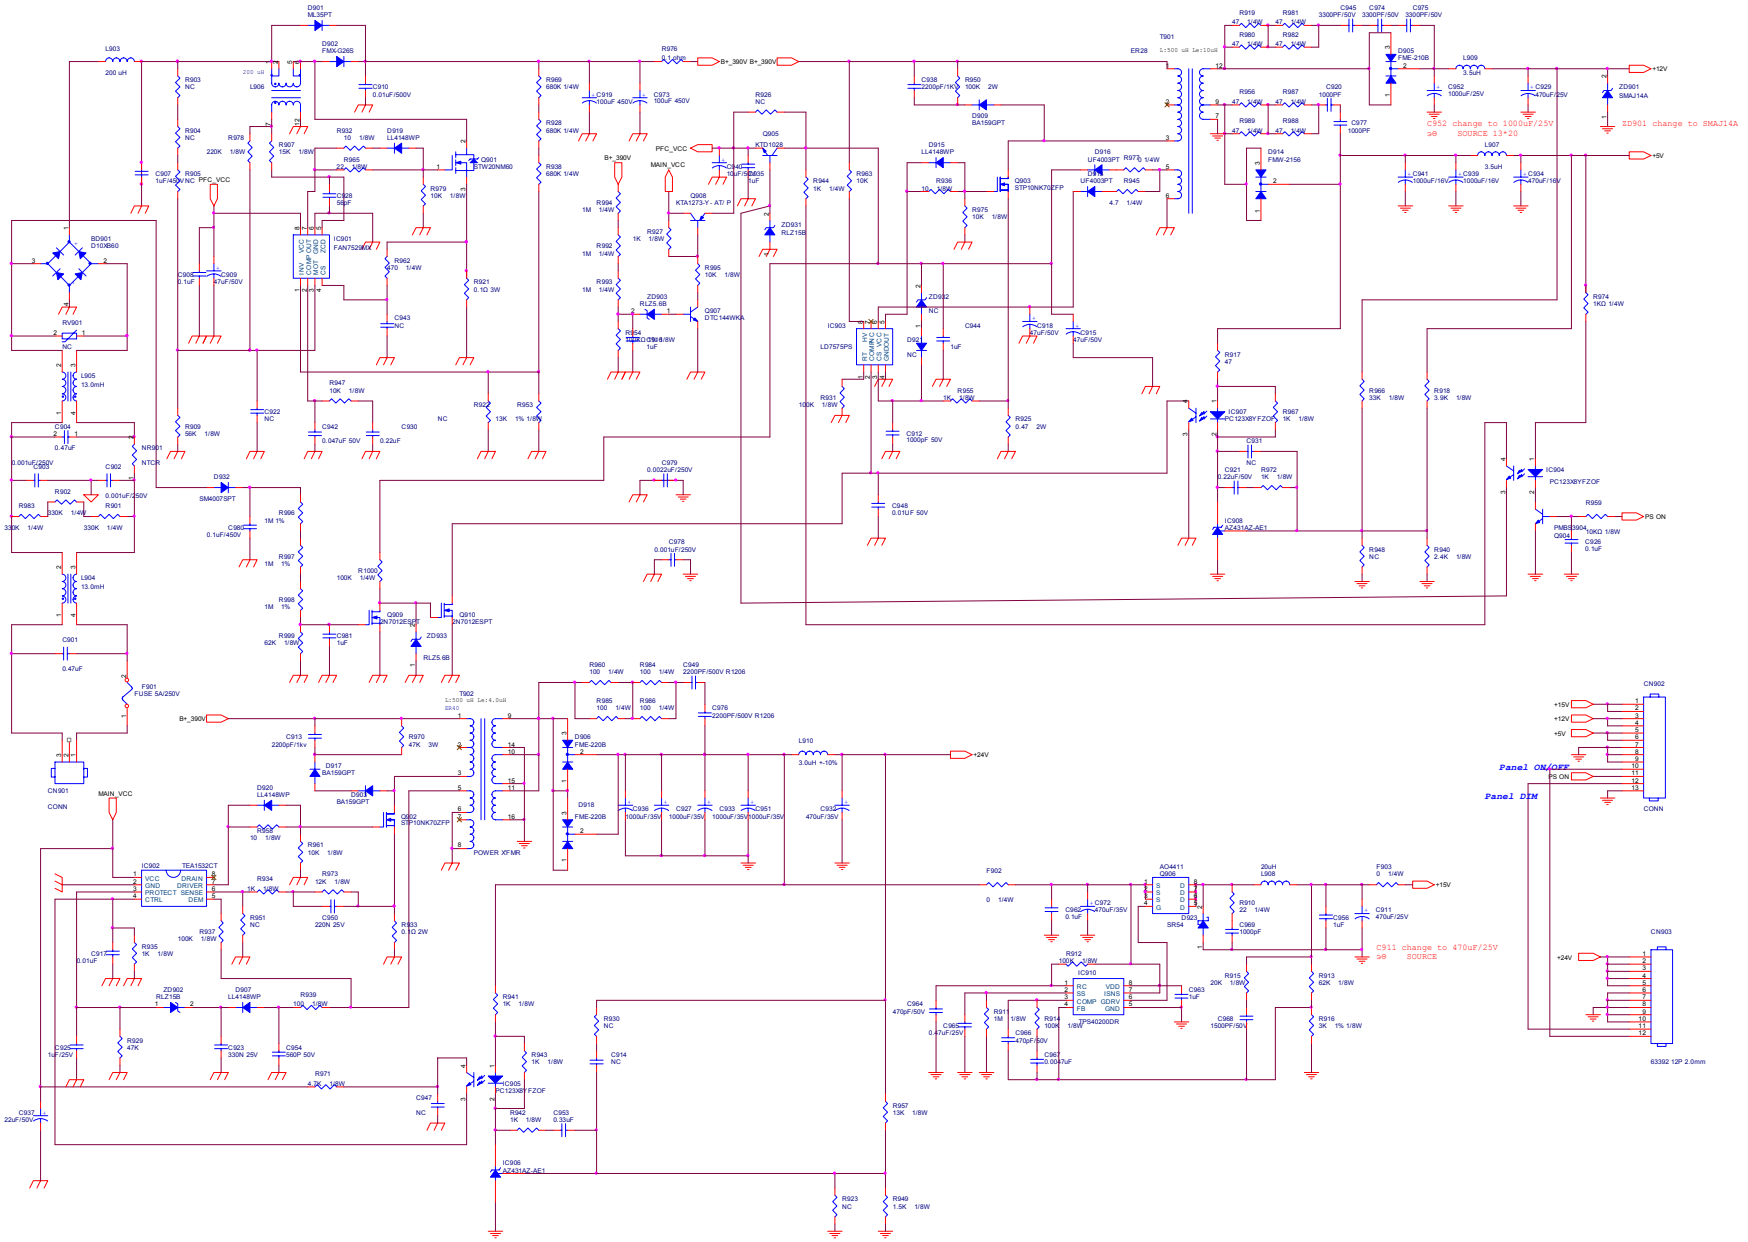
C952 change to 1000uF/25V
SOURCE 13*20
ZD901 change to SMAJ14A
C911 change to 470uF/25V
SOURCE
Panel ON/OFF
Panel DIM
POWER XFMR
63392 12P 2.0mm
